**A D D E N D U M # 1**

**DATE:** November 3, 2011

**PROJECT:** Gymnasium & Auditorium Restoration at South Middle School

**CBI JOB NO.:** 11063

**6 TYPICAL CLOSET INFILL DETAIL**  
SCALE: 1/8"=1'-0"

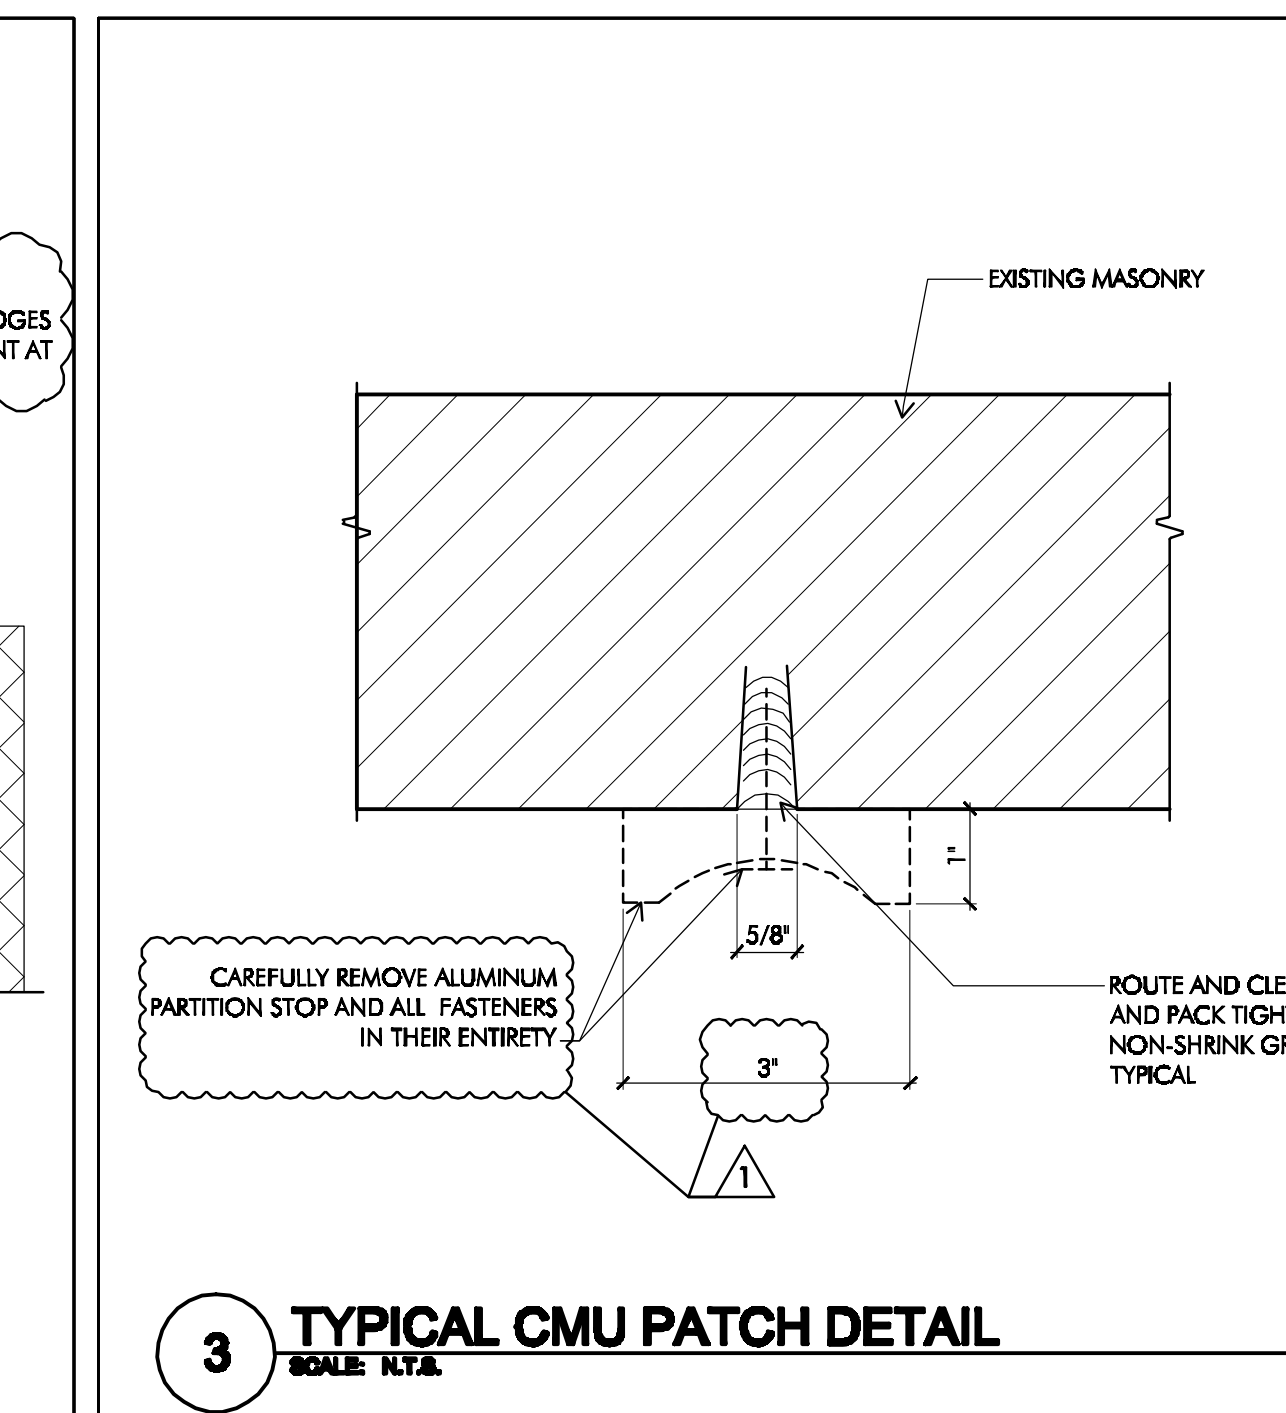
20. Sheet A1-05 – The detail tag at the movable partition enclosure calls out Detail 6/A5-01. This should read “Detail 6/A3-01”.
21. Sheet A2-01, at Drawings #1, at the detail at the existing wheelchair ramp with no notation, provide Oak veneer plywood in the triangle shape to cover the open space under the ramp. Provide floor blocking and a bullnose oak trim at the edge of the ramp at this location. Painting File Sub-Bidder to stain and coat with 3 coats of polyurethane.

**9 TYPICAL BLUEBOARD AND SKIM COAT PLASTER CEILING DETAIL AT ALL AUDITORIUM COFFERS**  
 SCALE: 3/4"=1'-0"

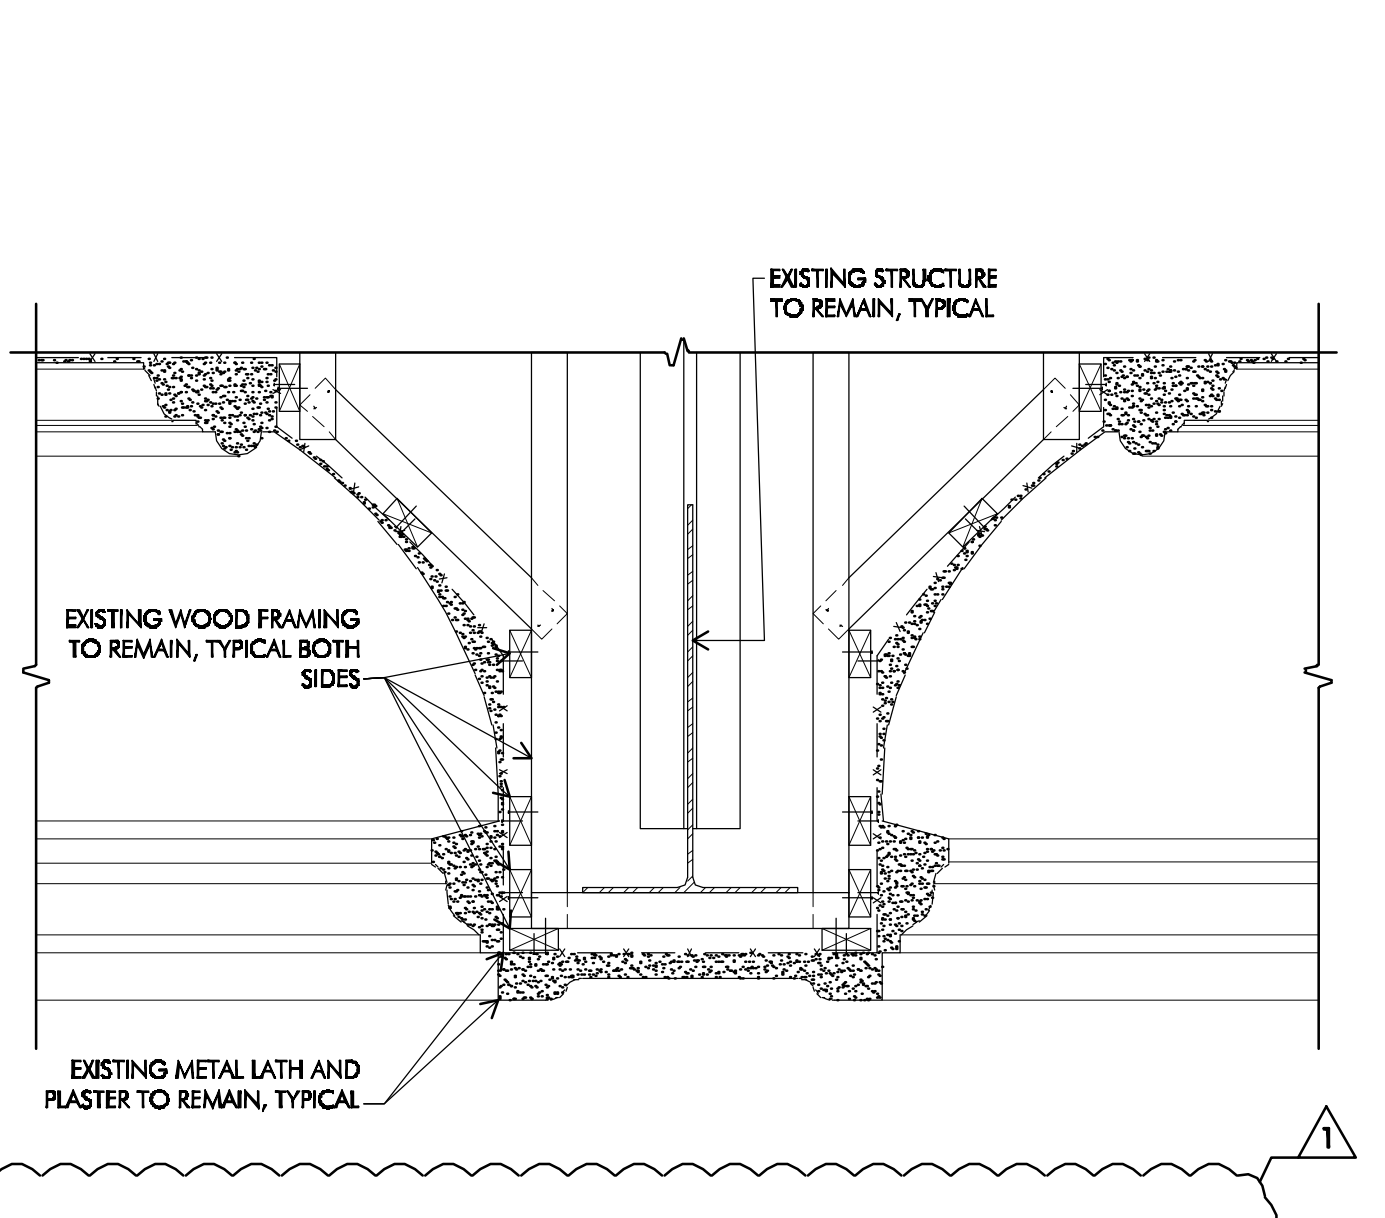
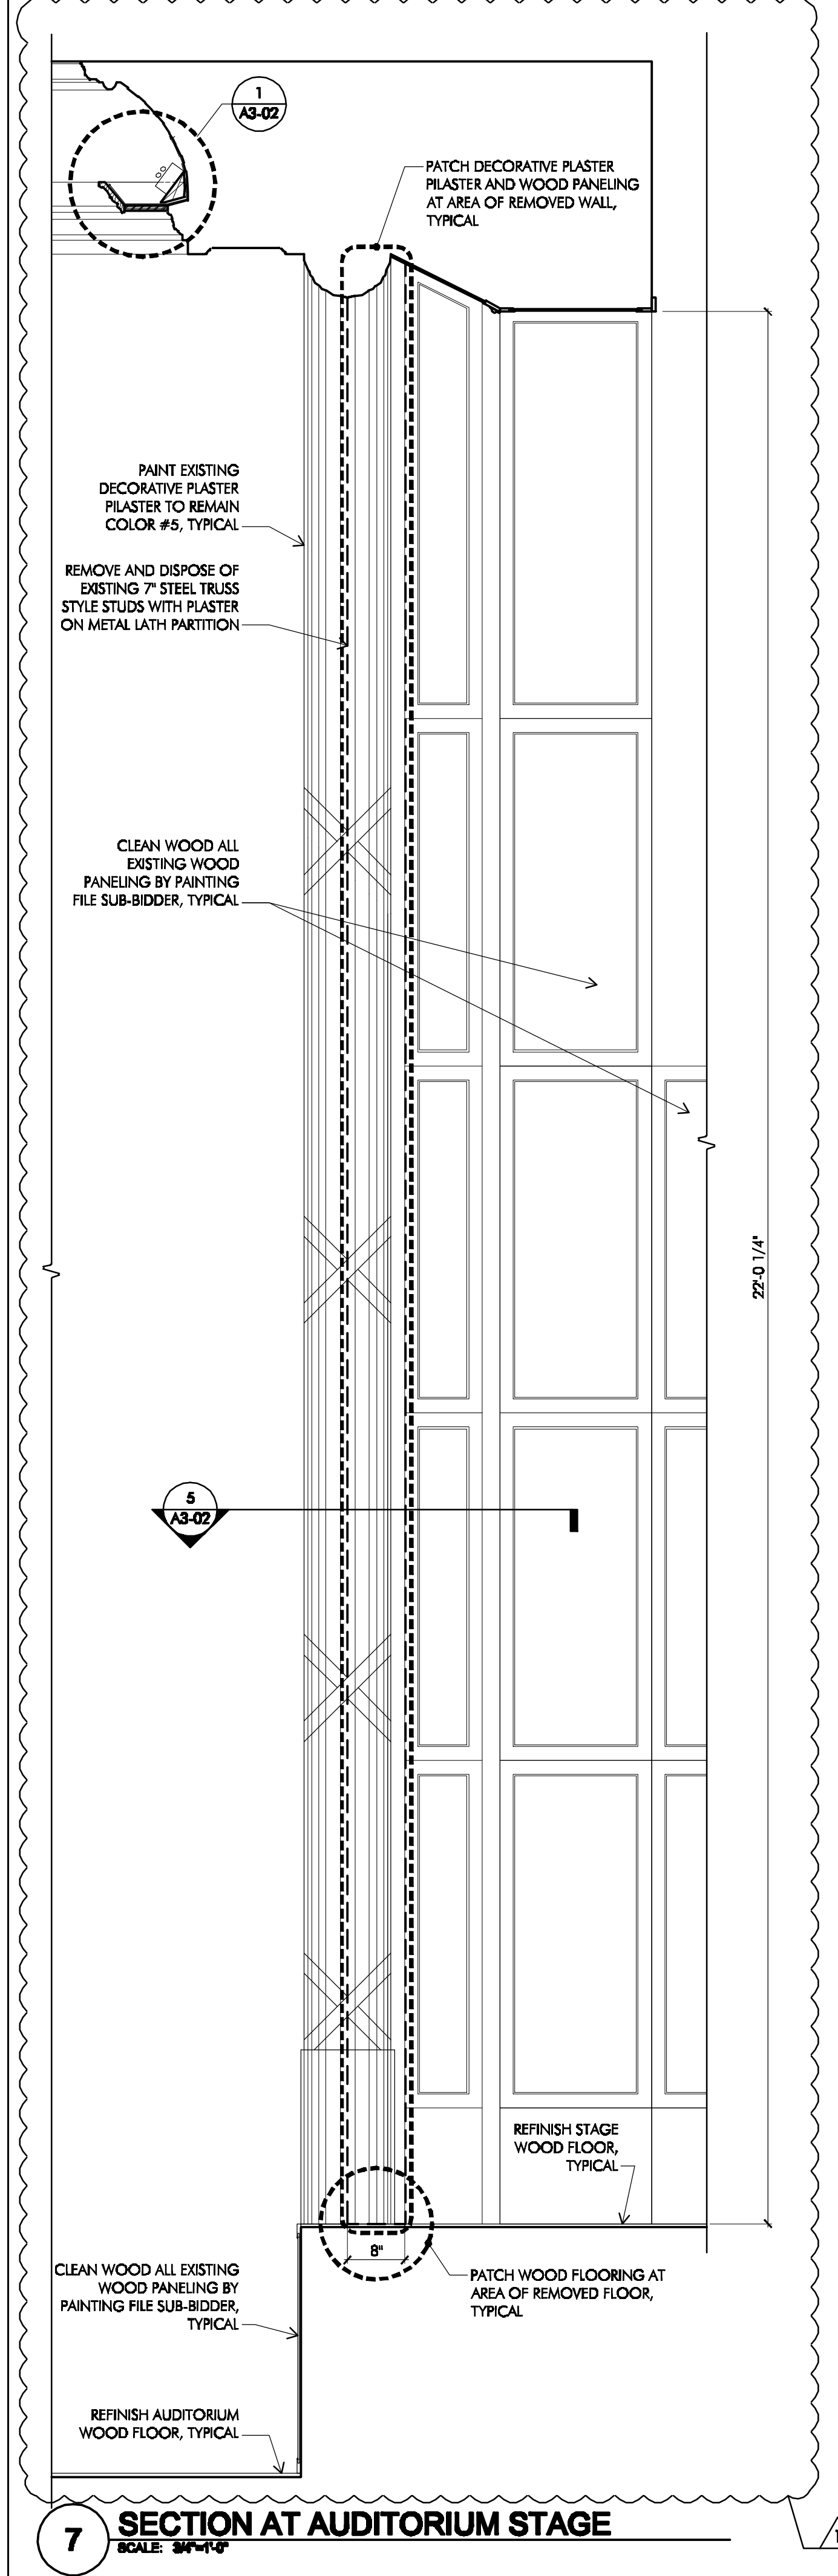
17. Access to the Crawl Space above the coffer ceiling is at the Third Floor Electrical Room just below the roof hatch.
18. At the ceiling of each coffer, DELETE patching all the small individual holes and install 3/8” blueboard with skimcoat plaster. Also provide a continuous J-Bead at the entire perimeter of each ceiling and a continuous paintable caulk bead. Paint entire assembly. The area noted to patch the Cast Plaster, located over the edge of the balcony, is still in the scope. Include in the scope the patching of holes in the ribs of the coffers – carry 50 small holes to be patched in the base contract.

42. Sheet A4-03, Photo Number 3, is a photo of the existing ceiling within each coffer that is punctured with the suspended ceiling wires and fasteners. Cover each ceiling in each coffer with 3/8" blueboard and skimcoat plaster. Also provide a continuous J-Bead at the entire perimeter of each ceiling and a continuous paintable caulk bead. Paint entire assembly.
